# DRAFT TECHNICAL REVIEW REPORT FOR THE LUANG PRABANG HYDROPOWER PROJECT – NAVIGATION

THE 9<sup>TH</sup> MRC REGIONAL STAKEHOLDER FORUM

DAY 1: THE 2<sup>ND</sup> REGIONAL INFORMATION SHARING ON PRIOR CONSULTATION FOR LUANG PRABANG HYDROPOWER PROJECT

05 FEBRUARY 2020, LUANG PRABANG, LAO PDR

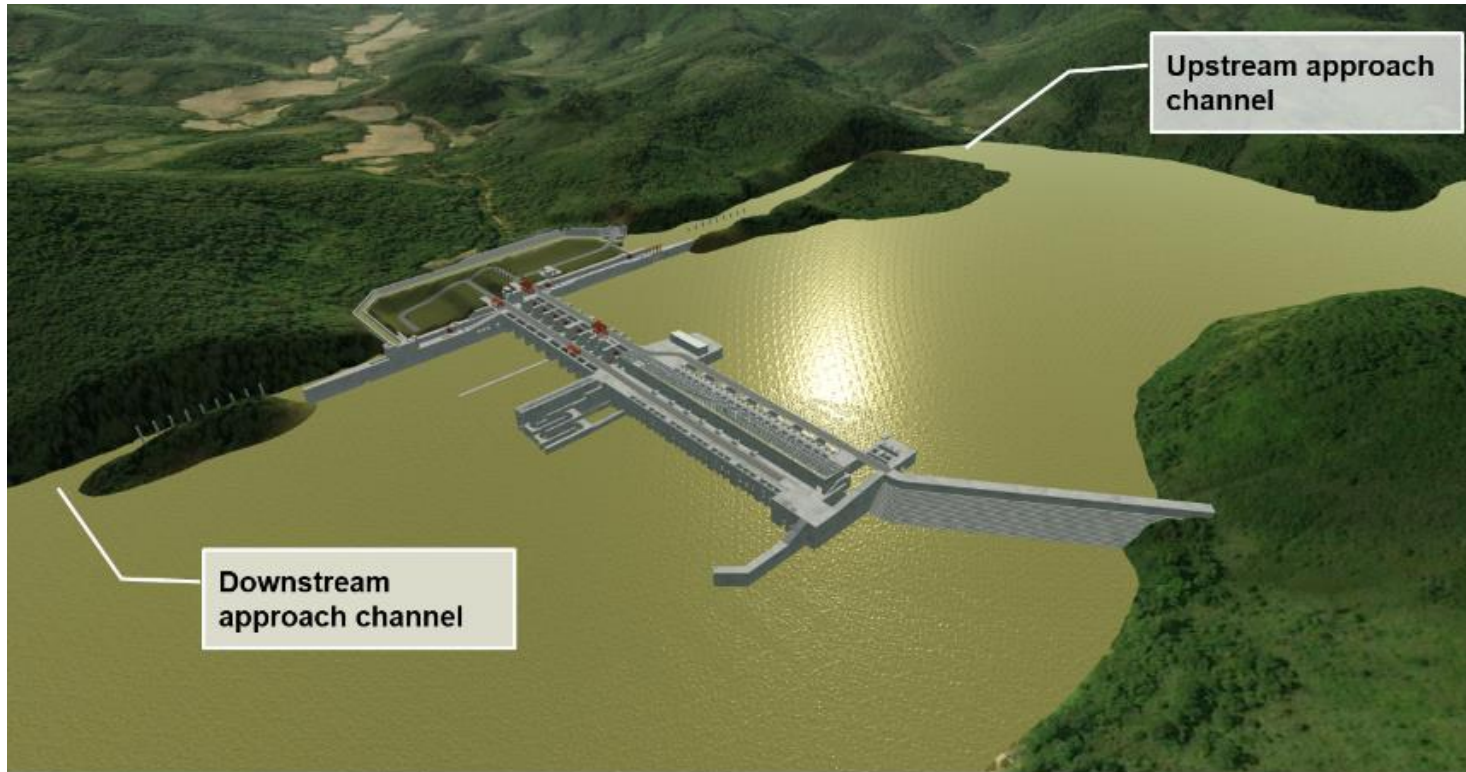
- The Feasibility Study only provides a brief description of the lock equipment (ladders, floating bits, wall armours, line hooks, etc.), but there is **no information on the numbers or exact location of this equipment.**
- Both lock chambers are long enough to accommodate the stoppage equipment, but **no detail of the stoppage-system** that will be used. Only three stoppage cables are needed, one of them being permanent (downstream the uppermost lock gate)

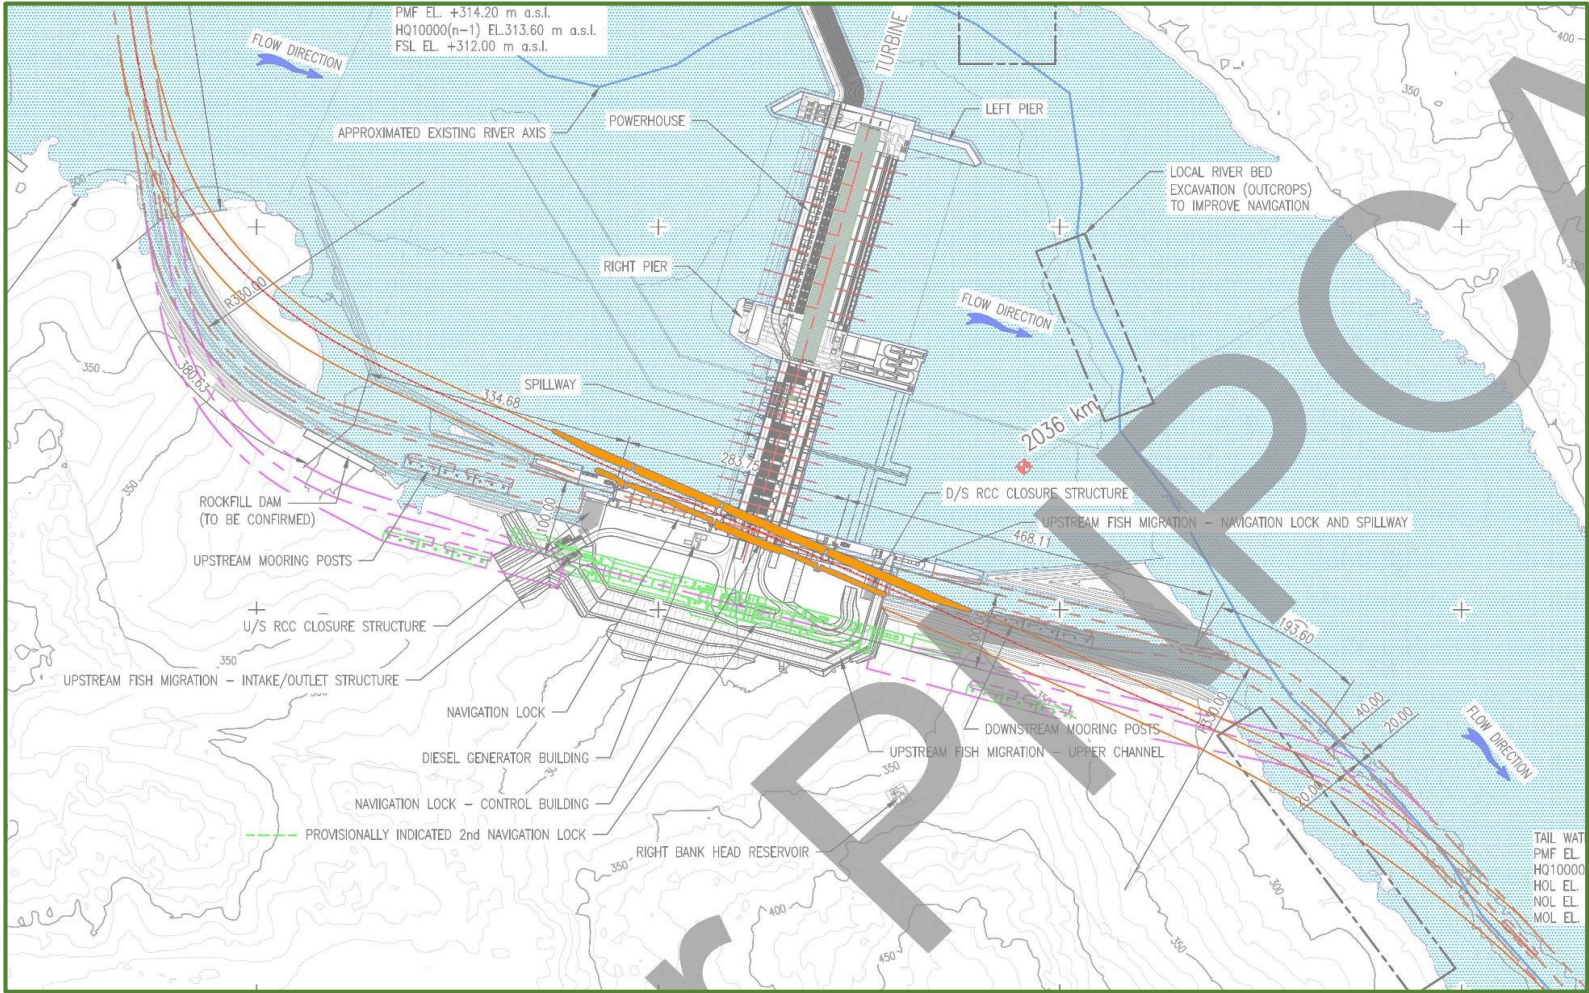
- The **upstream island may obstruct the view of the locks** and shipping in the resting areas, potentially posing a safety risk
- The documentation only mentions a **single lay-by area**, whereas the **PIANC guidelines recommend 3 areas**. All three must be linked to the mainland
- The provision of fresh water, waste collection and power supply not specified
- The **downstream channel is separated from the spillway by a short separation wall** which appears to tie into the downstream island
- *Improving the visibility inside the channel and reducing the risk the vessels may be sucked into the spillway by **decreasing this angle to 85° or 80°** (actual ship lock is 90° to the axis of the barrage) could possibly improve the layout of both access channels.*

- Consider the pros and cons of offsetting the **alignment of the navigation locks to 80 or 85 degrees from the 90 degree to the dam**;
- **Run hydraulic physical model tests** to determine the impacts of side currents between the downstream island and separating wall when the spillway is opened at full capacity;
